Subject: VIRGIL C. SUMMER NUCLEAR STATION  
DOCKET NO. 50/395  
OPERATING LICENSE NO. NPF-12  
TRANSMITTAL OF RADIATION EMERGENCY PLAN REVISION 50

DOCUMENT EP-100 REVISION 50 CHANGE N/A DATE 4/20/05

TITLE: Radiation Emergency Plan

Figure 2-2  
SITE ARRANGEMENT

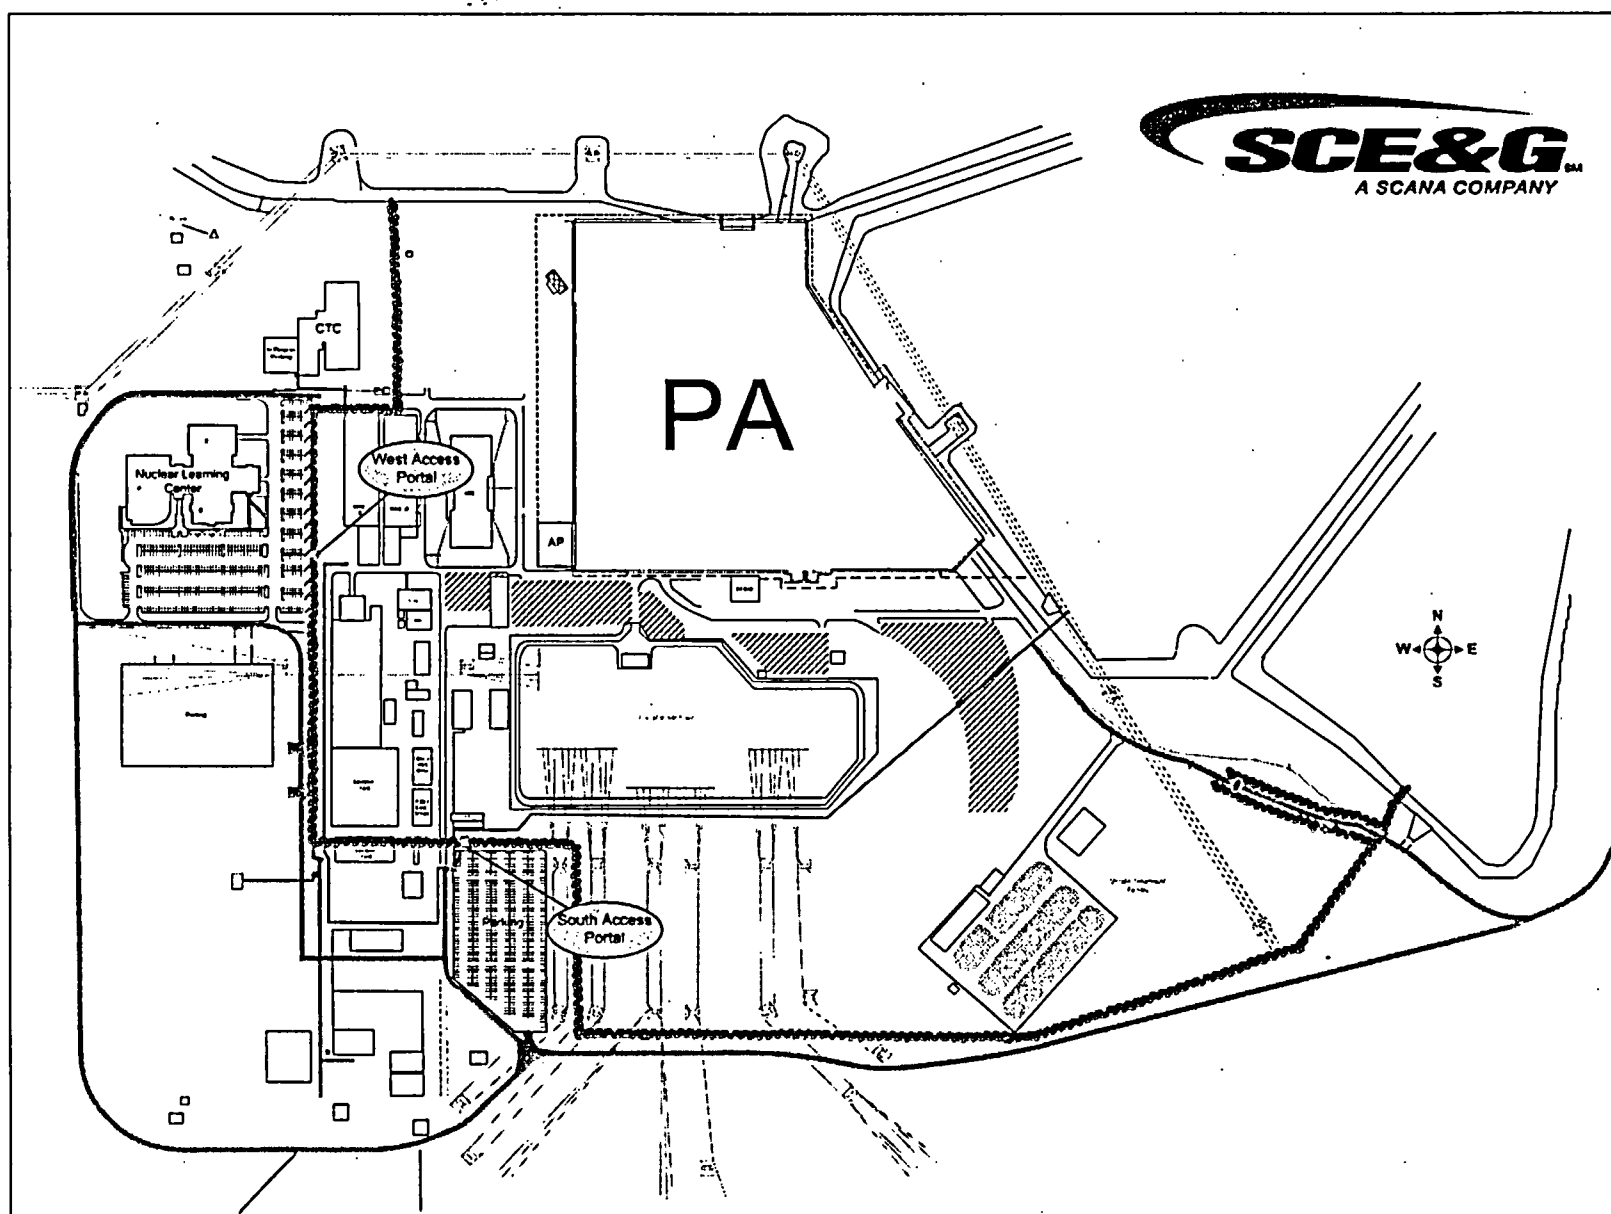
**Description:** Figure 2-2 – changed the map to the current version.

**Reason for Change:** The site profile has changed with the addition of buildings, barriers, etc.

**Figure 2-2** – changed the map to the current version.

Figure 2-7  
V.C. SUMMER EMERGENCY INTERRELATIONSHIPS WITH GOVERNMENT AGENCIES

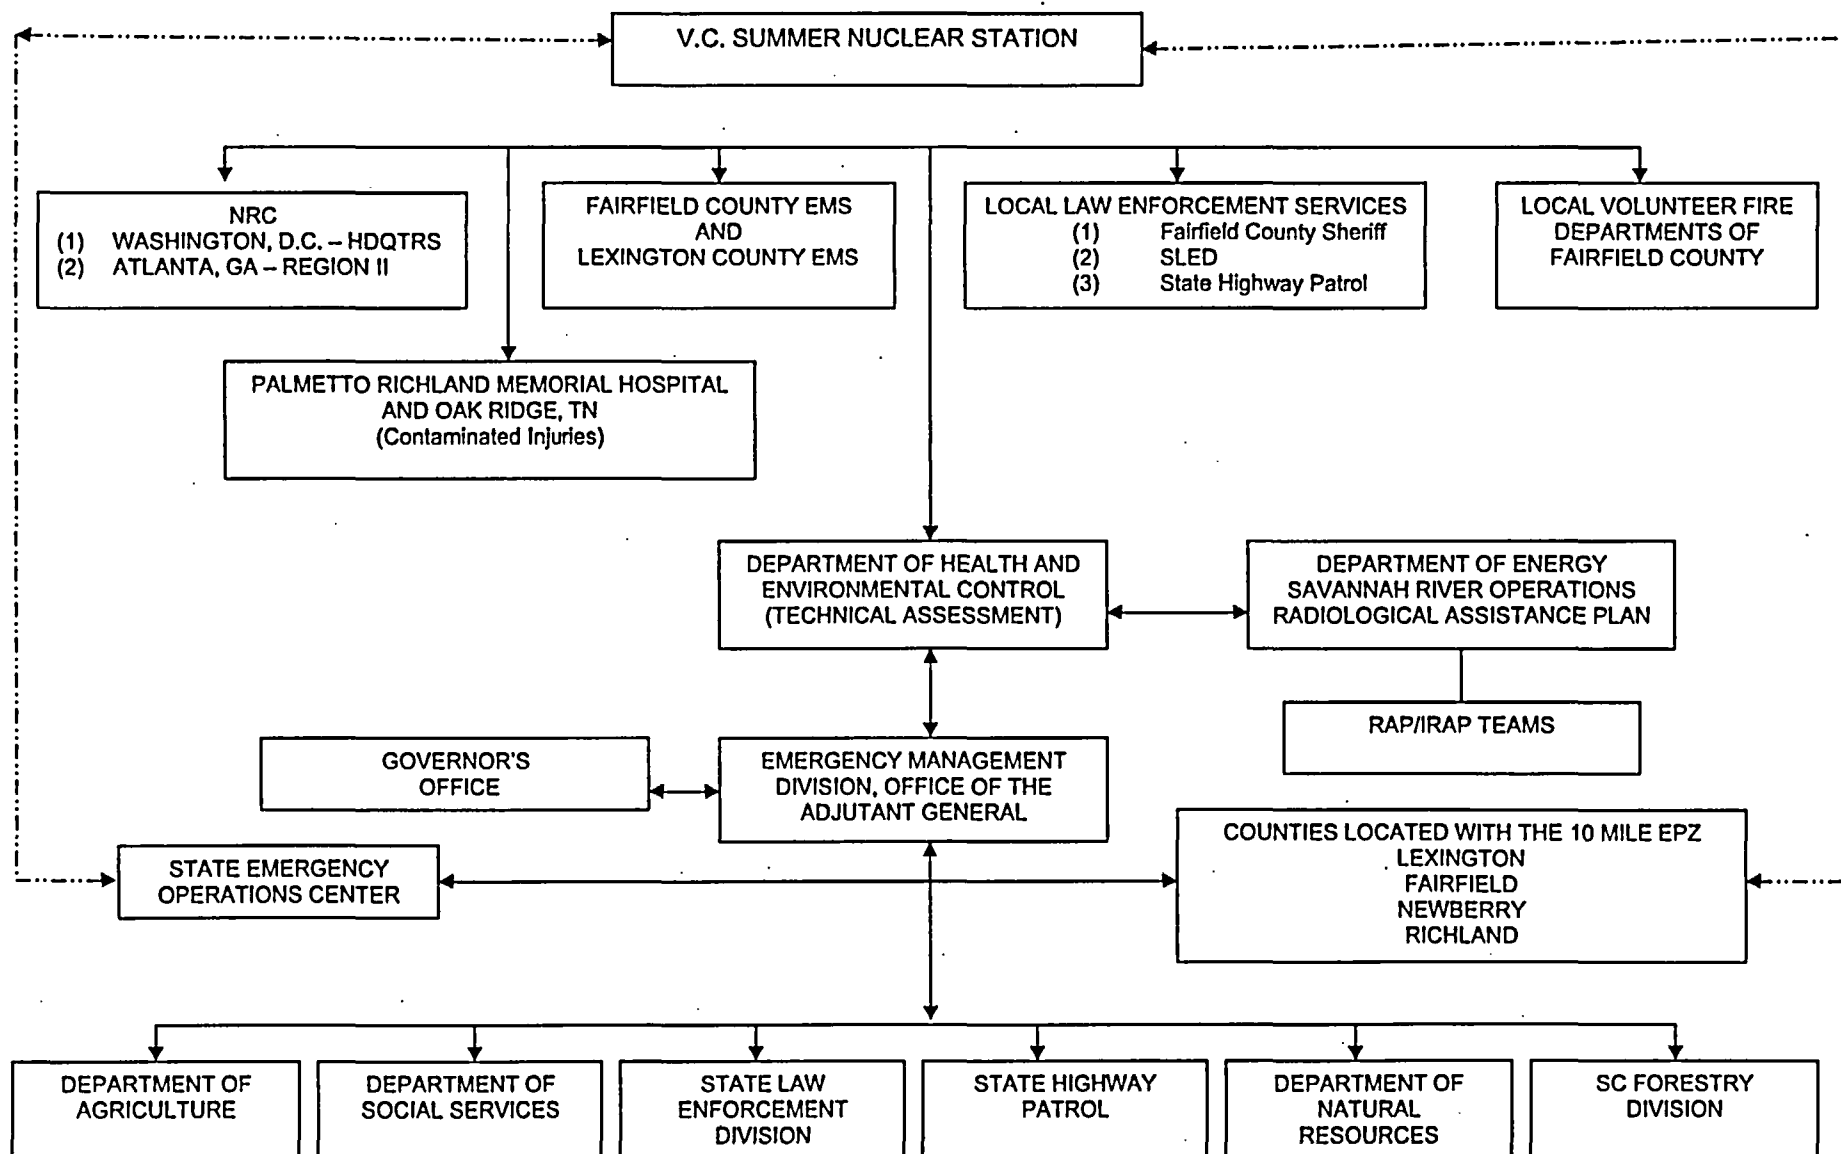
**Description:** Figure 2-7 – Editorial only.

**Figure 2-7** - editorial change.

**Figure 5-1**  
**SCE&G AND V. C. SUMMER NUCLEAR STATION FUNCTIONAL ORGANIZATION**

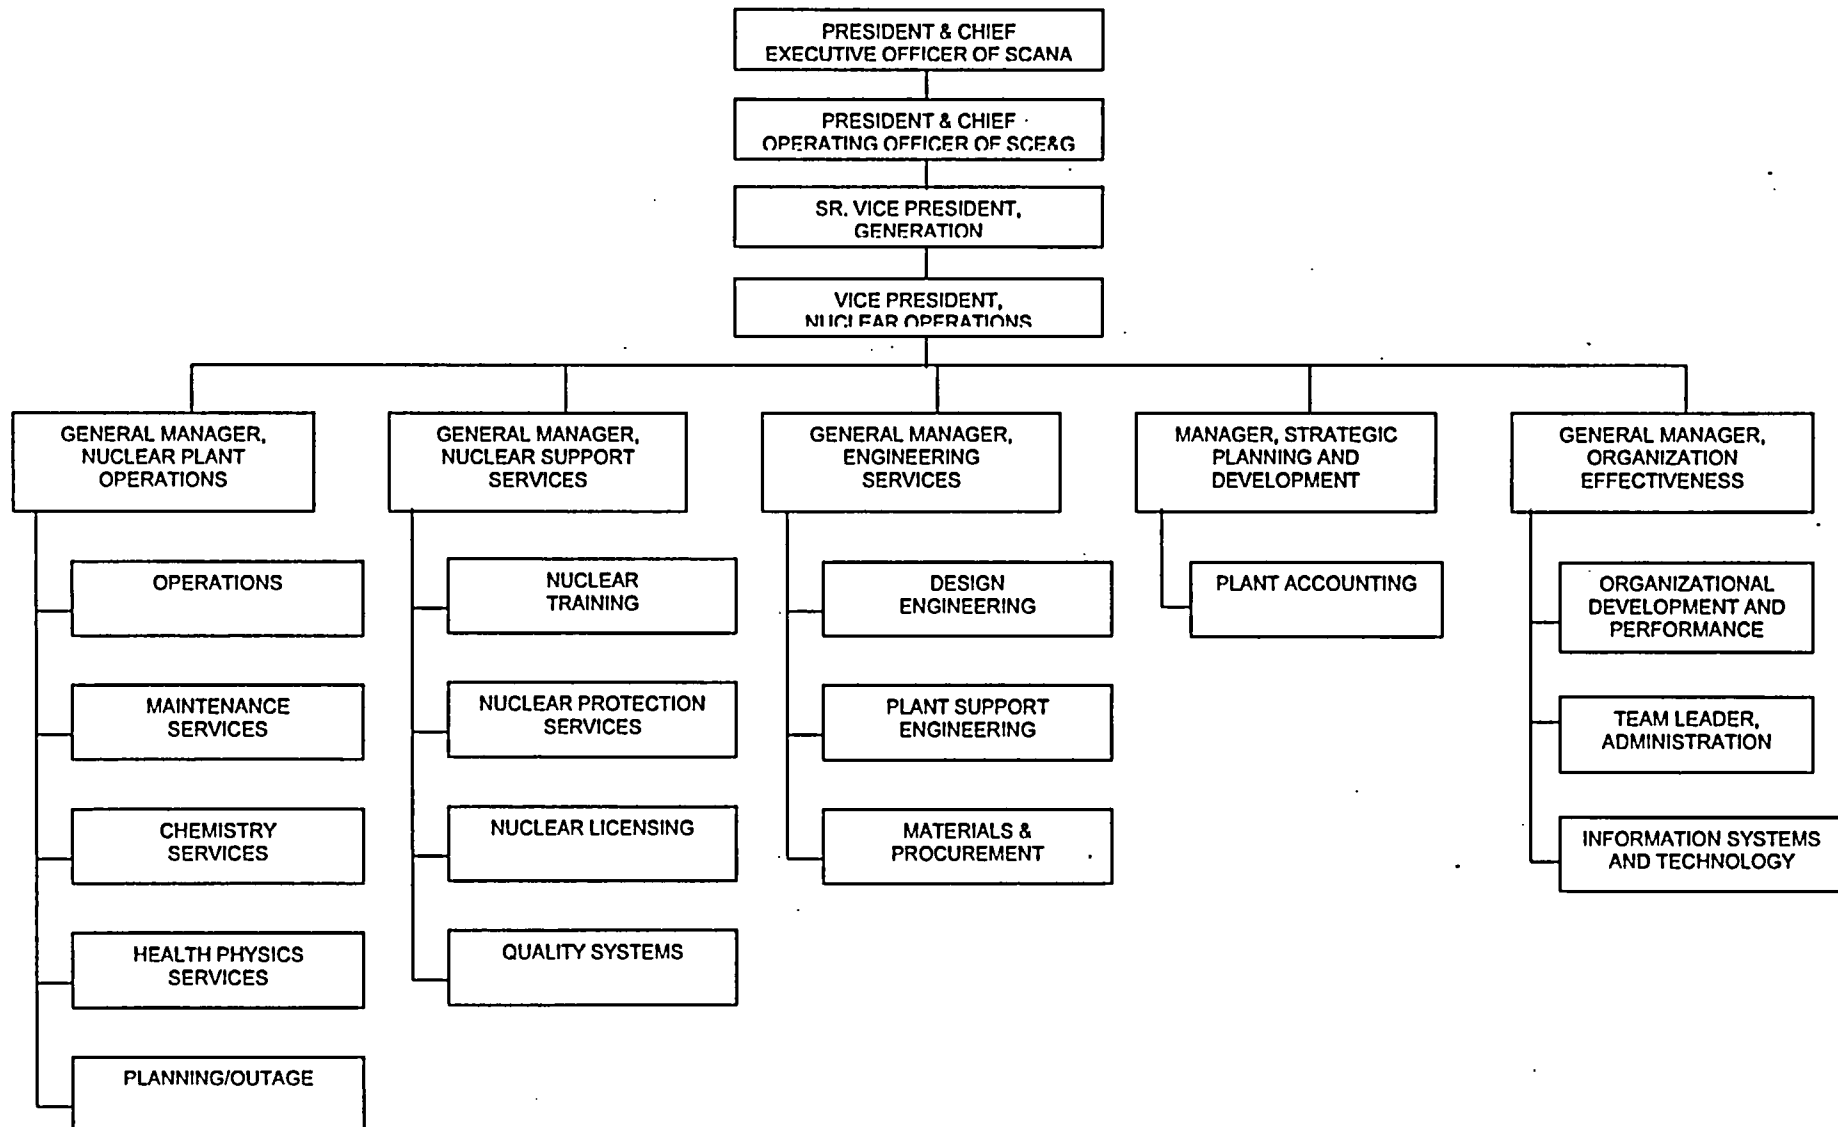
**Description:** Figure 5-1 –changed title to Vice President, Nuclear Operations and deleted Manager, Plant Life Extension. Added Sr. Vice President, Generation. Relocated Information Systems and Technology to the proper location.

**Reason for Change:** The individual who is Site Vice President is not a Senior Vice President. The Senior Vice President, Generation is the Chief Nuclear Officer. The position of Manager, Plant Life Extension no longer exists.

**Figure 5-1** –changed title to Vice President, Nuclear Operations and deleted Manager, Plant Life Extension. Added the title Sr. Vice President, Generation.

Table 6-3  
PROTECTIVE ACTION RECOMMENDATIONS

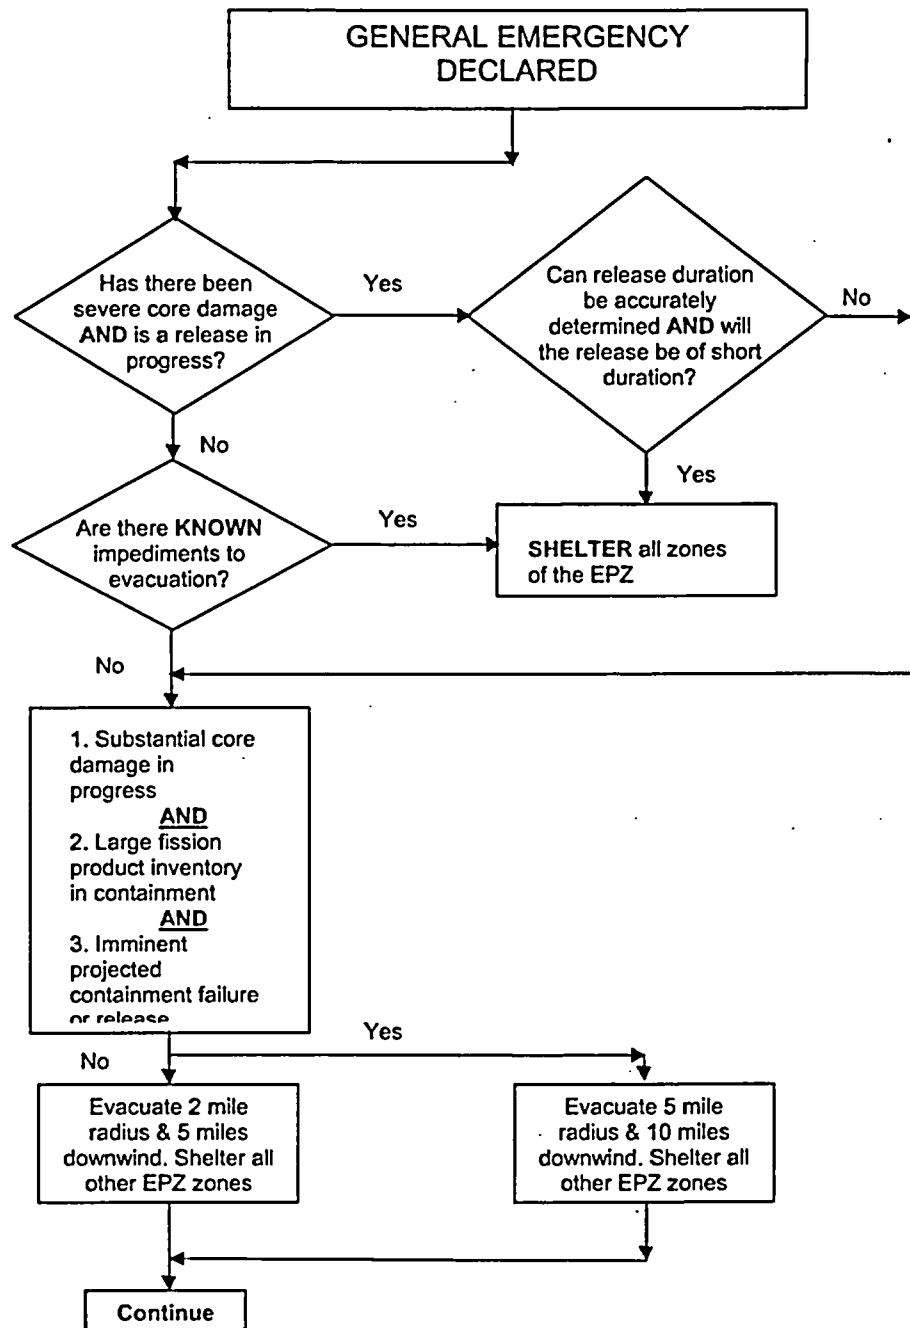
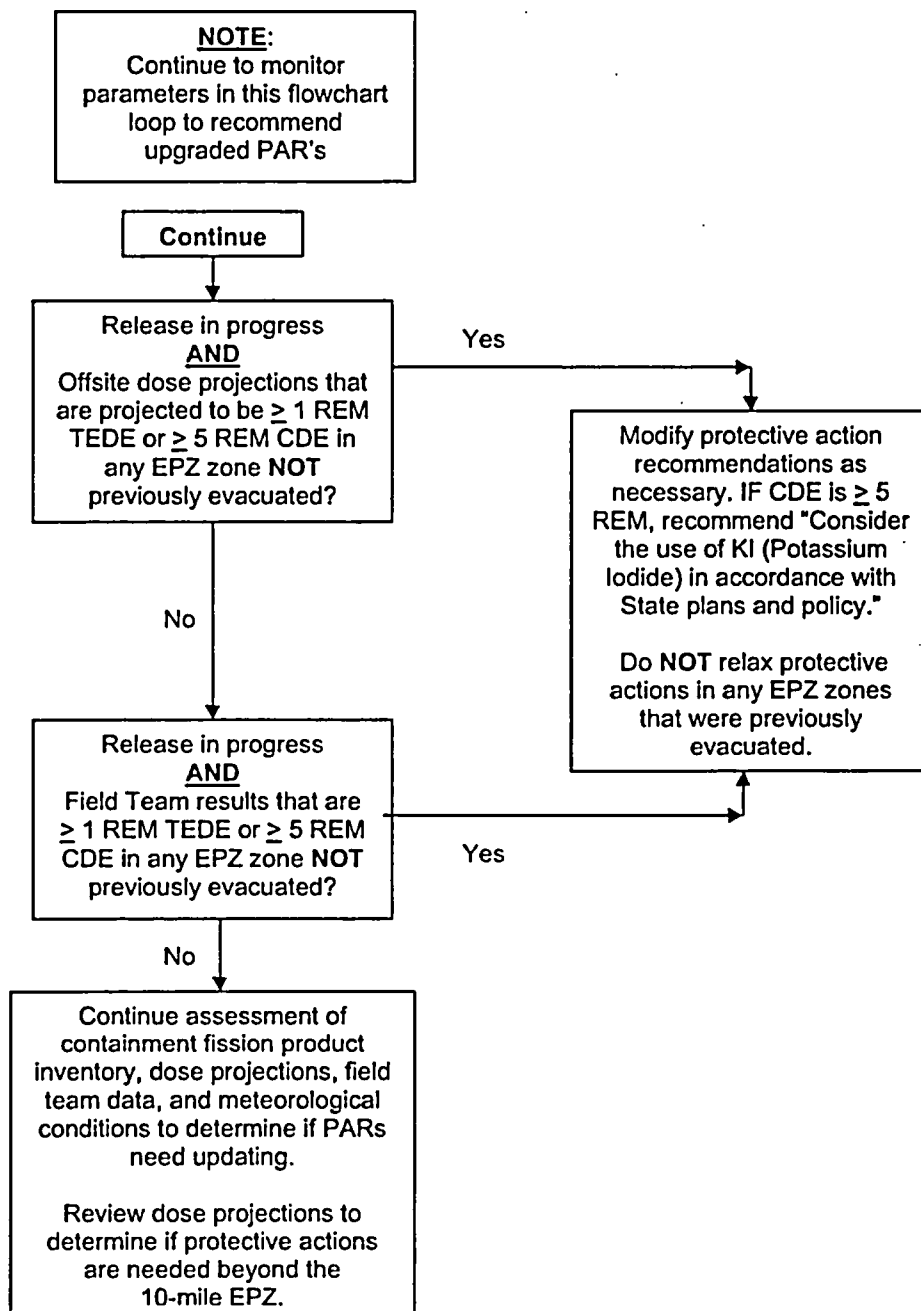
**Description:** Tables 6-1 and 6-3 – added the consideration of sheltering as a protective measure for the public.

**Reason for Change:** Mandated by NRC Regulatory Issue Summary 2004-13, Supplement 1, Consideration of Sheltering in Licensee's Range of Protective Action Recommendations, dated August 2004.

**Tables 6-1 and 6-3** – added the consideration of sheltering as a protective measure for the public.

**Figure 7-1**  
**EMERGENCY FACILITIES GENERAL LOCATION**

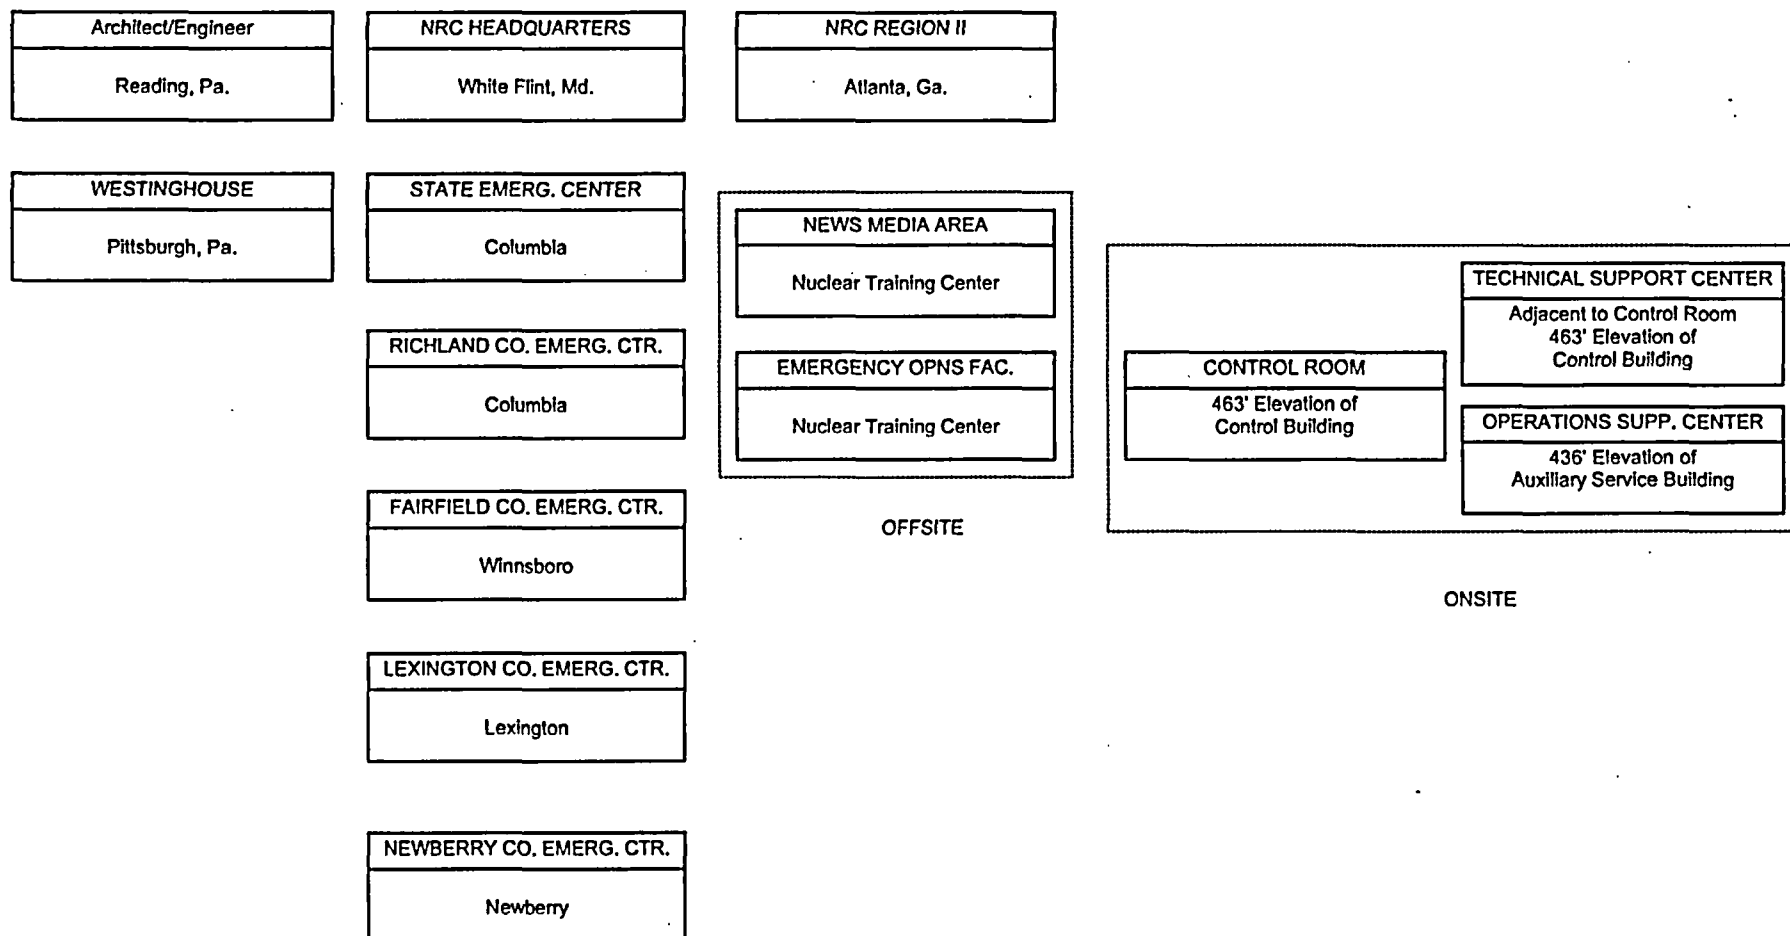
**Description:** Sections 6.4.2 d., Section 7.1.2 and Figure 7-1 – changed the location of the Operations Support Center to the 436' elevation of the Auxiliary Service Building. Stated that a back-up facility is maintained on the 448' elevation of the Control Building.

**Reason for Change:** The location of the OSC is being changed due to the physical limitations of the current location. The new location has improved facilities, more room and a layout that will allow an improvement in communication flow and team dispatch. All supplies and equipment located in the current location will be moved to the new location. Since there may be a reduction in capability of the new location, the current location on the 448' elevation will be maintained as a back-up facility.

**Sections 6.4.2 d., Section 7.1.2 and Figure 7-1** – changed the location of the Operations Support Center to the 436' elevation of the Auxiliary Service Building. Stated that a back-up facility is maintained on the 448' elevation of the Control Building.
